Subject: Virgil C. Summer Nuclear Station (VCSNS) Units 2 and 3 Combined License Application (COLA) - Docket Numbers 52-027 and 52-028 Response to NRC Request for Additional Information (RAI) Letter No. 058

Reference: Letter from Chandu P. Patel (NRC) to Alfred M. Paglia (SCE&G), Request for Additional Information Letter No. 058 Related to SRP Section 02.05.01 for the Virgil C. Summer Nuclear Station Units 2 and 3 Combined License Application, dated July 15, 2009.

**NRC RAI Letter No. 058 Dated July 15, 2009**

**SRP Section: 02.05.01 – Basic Geologic and Seismic Information**

Attachment 1  
Revised FSAR Figure 2.5.1-212

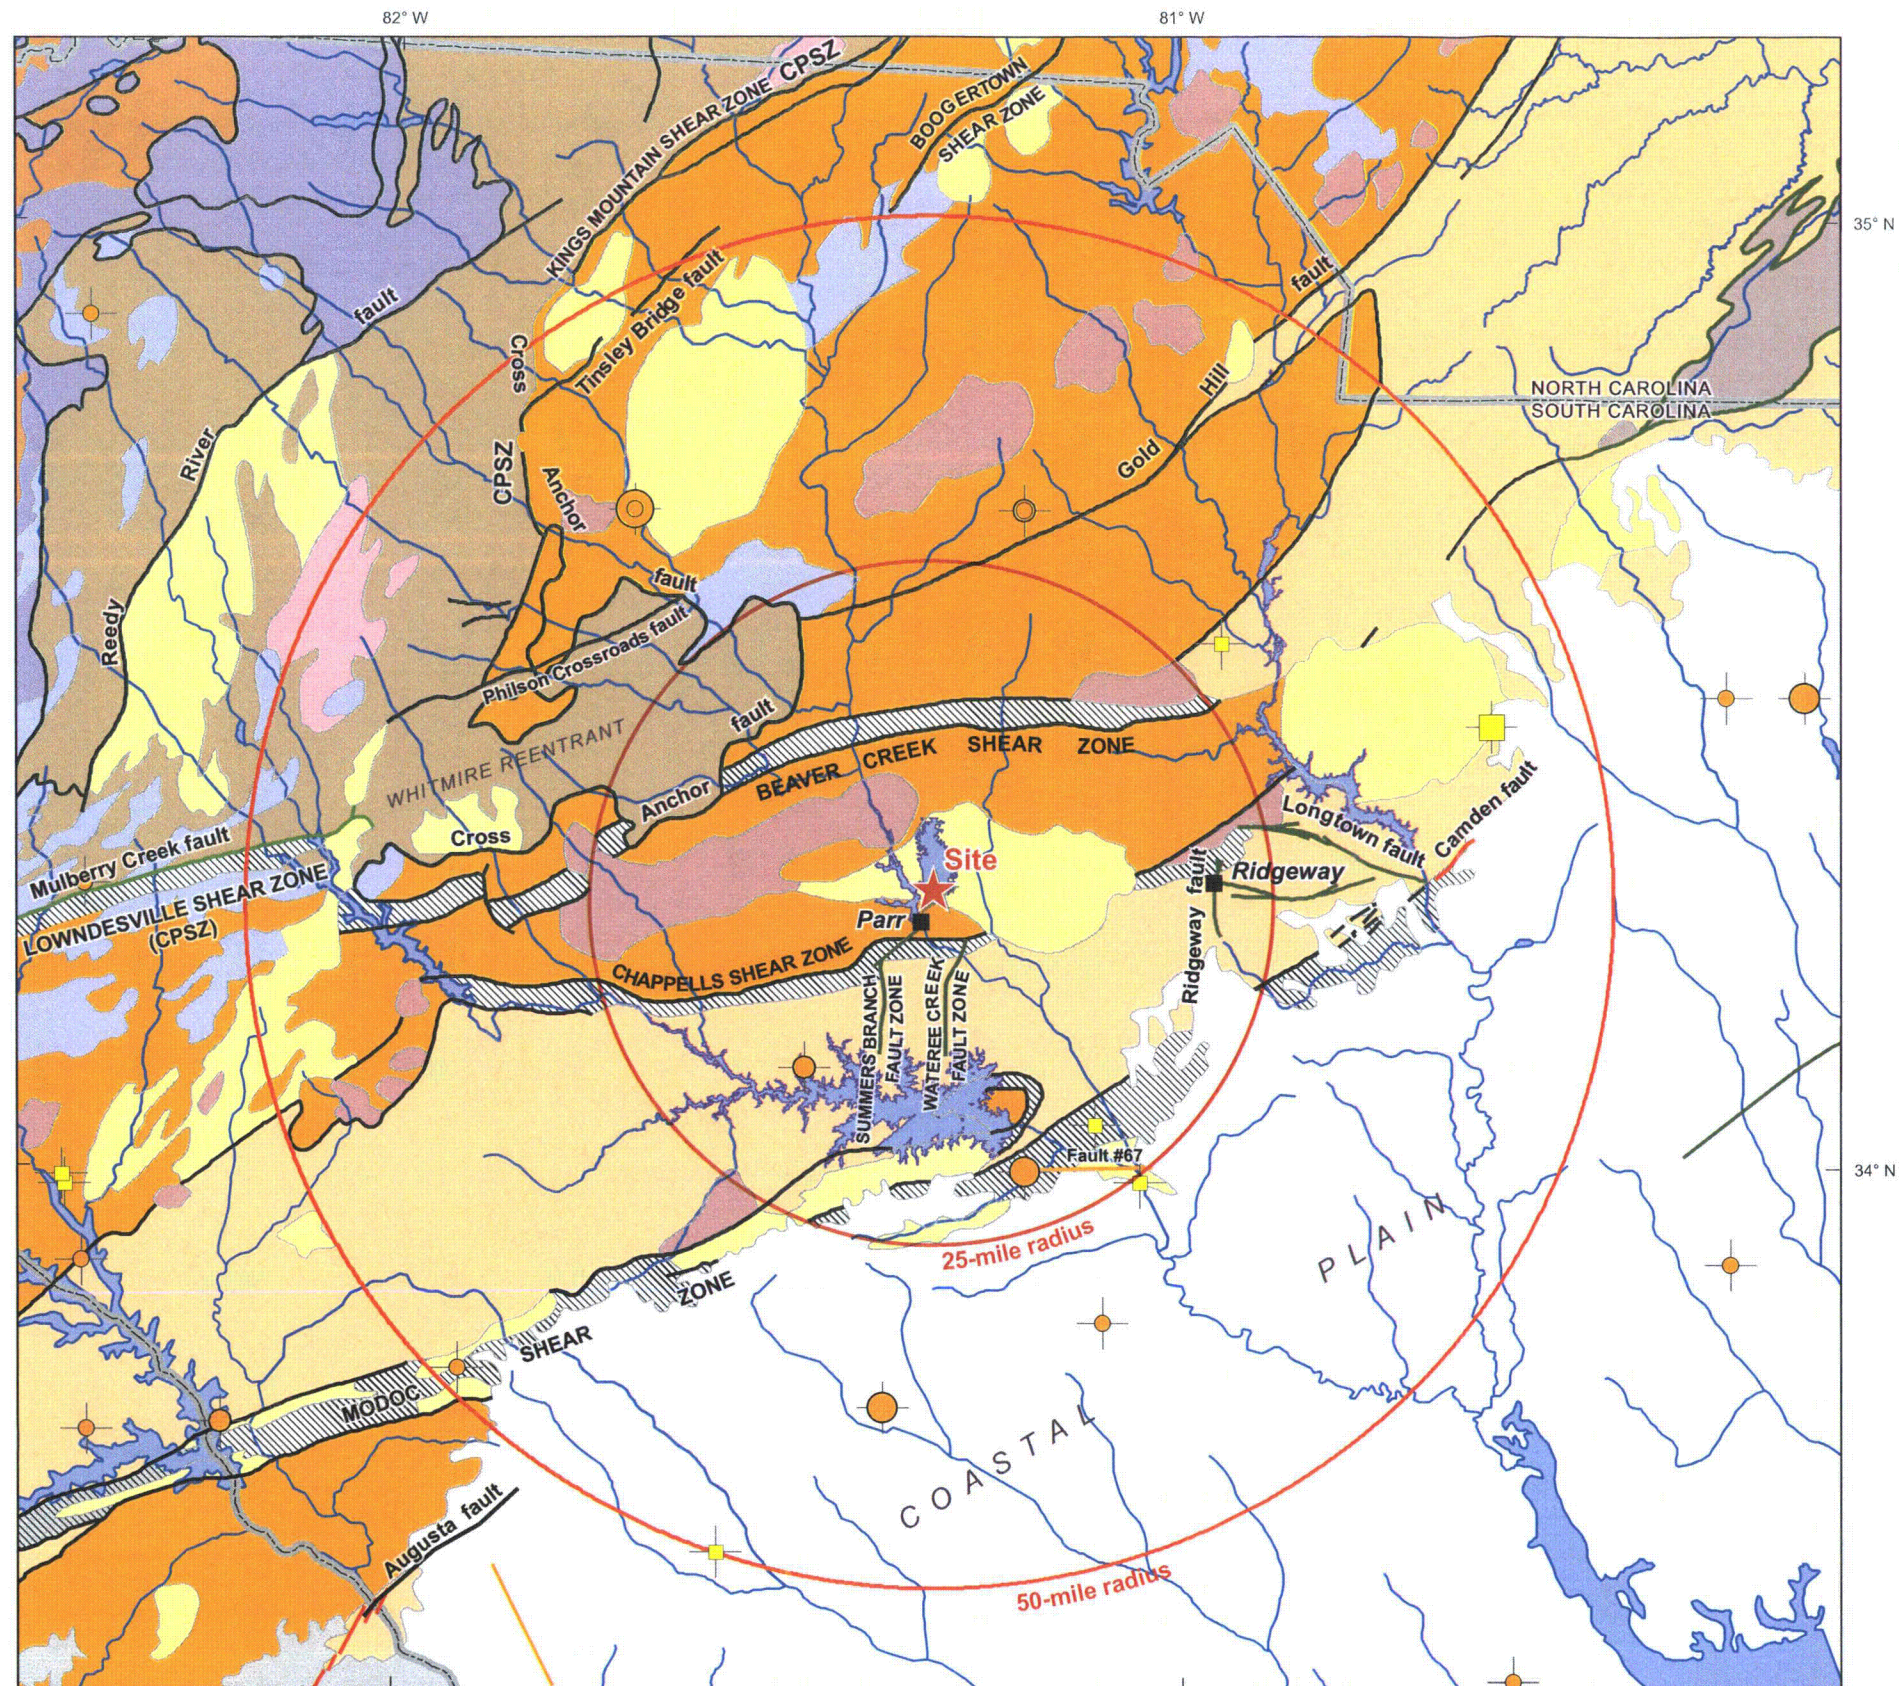
The response to RAI 2.5.1-21 discussed information related to the age of the Mulberry Creek fault and the timing of the development of silicified fault breccias in the site region, including a summary of the supporting data from West (1998) used to conclude that the fault is Mesozoic in age and a revised FSAR Figure 2.5.1-212. The response specifically cited the more recent work of Hatcher and others (2006) which corroborated a Mesozoic age for the Mulberry Creek fault, and clarified that Nystrom (2006) did not interpret Cenozoic movement on any faults in the region based on the presence of silicified breccias. FSAR Section 2.5.1.1.2.4.2 does not presently contain this information, and the RAI response did not indicate that the FSAR would be revised to include it for constraining age of the Mulberry Creek fault. In addition, the “diagonal line” symbol is not included in the legend of revised Figure 2.5.1-212.

Please include key parts of the response to RAI 2.5.1-21 in a revised FSAR Section 2.5.1.1.2.4.2 to document the conclusion that the Mulberry Creek fault is Mesozoic in age. Please also include the “diagonal line” symbol in the legend of revised Figure 2.4.1-212.

Additionally, FSAR Figure 2.4.1-212 will be revised to include the diagonal line symbol in the explanation. The diagonal line symbol in FSAR Figure 2.5.1-212 indicates shear zones that are mapped in their original source reference as having width greater than the plain line width in FSAR Figure 2.5.1-212.

3. FSAR Figure 2.5.1-212 will be revised to include the "diagonal line" symbol in the figure key, as shown in Attachment 1.
